Gilpin Property, Phase III

DSP-13008-02

STAFF REPORT

SUBJECT: Detailed Site Plan DSP-13008-02
 Type 2 Tree Conservation Plan TCP2-018-13-02
 Gilpin Property, Phase III

Figure 1: Illustrative Site Plan

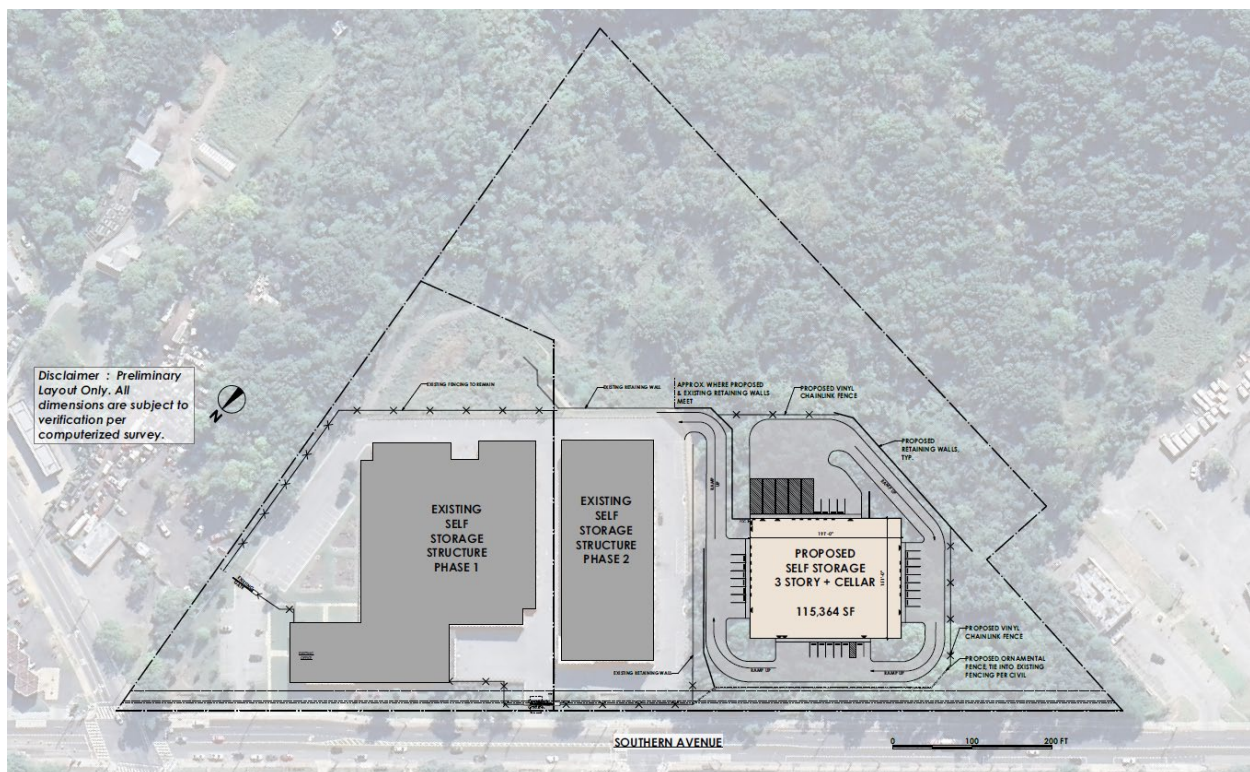
6. **Design Features:** The site contains two existing consolidated storage buildings with a total of 157,262 square feet and 1,463 storage units. This DSP amendment proposes a third consolidated storage building consisting of three stories, 1,077 units, and 115,364 square feet to the south of the existing building. The site already has two vehicular access points from Southern Avenue, with access gates and fencing surrounding the site. This DSP includes 25 parking spaces, which surround the proposed building, one of which is handicap-van accessible. On the eastern side are five 15-foot by 45-foot loading spaces.

The overall site has one proposed entry/exit point along Southern Avenue. Two truck turning exhibits were also provided to demonstrate the ability for large vehicles to maneuver through the site. Sidewalks are proposed adjacent to all entrances. Given the topography of the site, sidewalks are not continuous, and given the unique characteristics of the site, it is not possible to provide a continuous pedestrian route along the proposed building. All

proposed parking spaces are located along the perimeter of the building, allowing easy use for loading and unloading, while also alleviating the need for pedestrians to cross parking lanes.

Figure 2: Northern Architectural Elevation

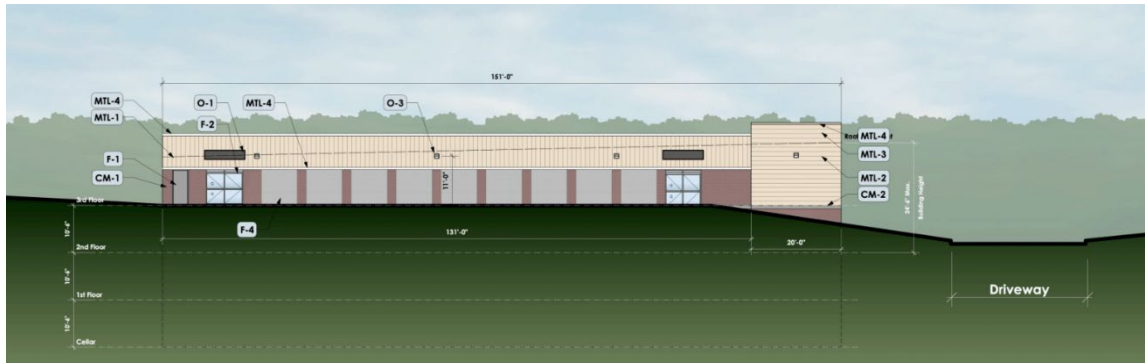
The applicant is proposing a modern architecture style for the building. With the subject of this project being the third storage building on this property, the building will have similar materials and a similar color scheme with the existing buildings. The building materials will consist of a combination of masonry and decorative metal siding. The building will include decorative canopies, colored wall panels, automatic sliding doors, and storage rollup doors in loading areas. The building will be three stories and 31.5 feet tall.

The design of the proposed consolidated storage facility is a modern style. The building footprint is rectangular, and the building is designed with a flat roof. The metal decorative canopy above doors indicates the locations of the entrances to the building. A detailed discussion regarding architecture has been addressed in Finding 6 above.
